VICTORIA SPRINGS SUBDIVISION, RESUBDIVISION OF LOT 2

VICTORIA SPRINGS SUBDIVISION, RESUBDIVISION OF LOT 2

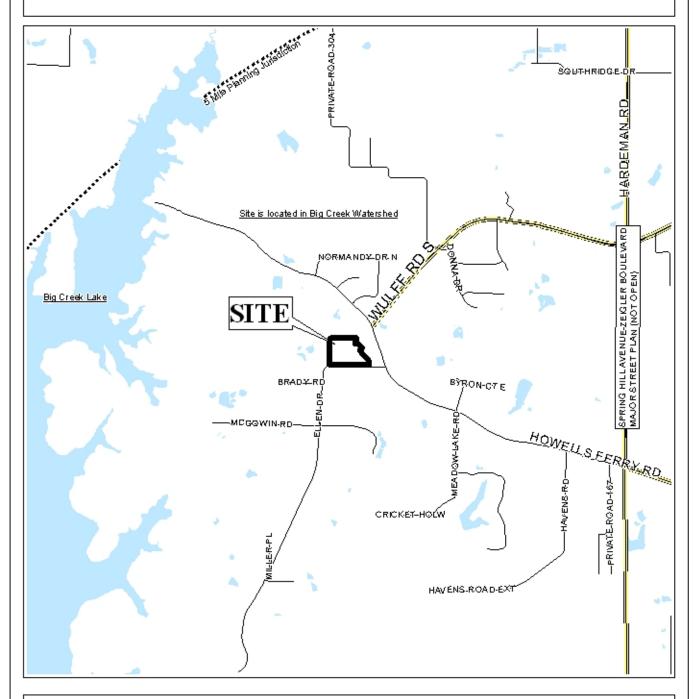
The site fronts on Ellen Drive, a minor street with adequate existing right of way of 60' in front of the proposed lot; therefore, no dedication would be required. As a means of access management, a note should be placed on the final plat stating that Lot 1 is limited to one curb cut to Ellen Drive, with the size, location and design to be approved by County Engineering and conform to AASHTO standards.

No building setback line is indicated on the plat; therefore, the plat should be revised to indicate a 25' minimum building setback line along Ellen Drive. The lot is not labeled with its size; therefore, the lot should be labeled with its size in square feet and acres, or a table should be provided on the plat furnishing the same information. The remainder of Lot 2, Victoria Springs Subdivision is labeled as "Future Development" and should also be labeled as such on the final plat.

A note should be placed on the Final Plat stating that any lots which are developed commercially and adjoin residentially developed property must provide a buffer, in compliance with Section V.A.7. of the Subdivision Regulations.

- 1) placement of a note on the final plat stating that Lot 1 is limited to one curb cut to Ellen Drive, with the size, location and design to be approved by County Engineering and conform to AASHTO standards;

- 2) depiction of the 25' minimum building setback line along Ellen Drive;
- 3) labeling of Lot 1 with its size in square feet and acres, or the provision of a table on the plat furnishing the same information;

- 4) labeling of the remainder of Lot 2, Victoria Springs Subdivision, as "Future Development";
- 5) provision of a minimum detention capacity volume of a 50 year post development storm, with a maximum release rate equivalent to the 10 year storm pre-development rate, and the placement of a note on the final plat stating that the development will be designed to comply with all other storm water detention and drainage facility requirements of the City of Mobile storm water and flood control ordinances, and requiring submission of certification from a licensed engineer certifying that the design complies with the storm water detention and drainage facility requirements of the City of Mobile storm water and flood control ordinances, as well as the detention and release rate requirements of Mobile County for projects located within the Converse watershed, prior to the obtaining of permits. Certification is to be submitted to the Planning Section of Urban Development and County Engineering;

- 6) placement of a note on the plat stating that the site must be developed in compliance with all local, state and Federal regulations regarding endangered, threatened or otherwise protected species; and

7) placement of a note on the final plat stating that any lots which are developed commercially and adjoin residentially developed property must provide a buffer, in compliance with Section V.A.7. of the Subdivision Regulations.
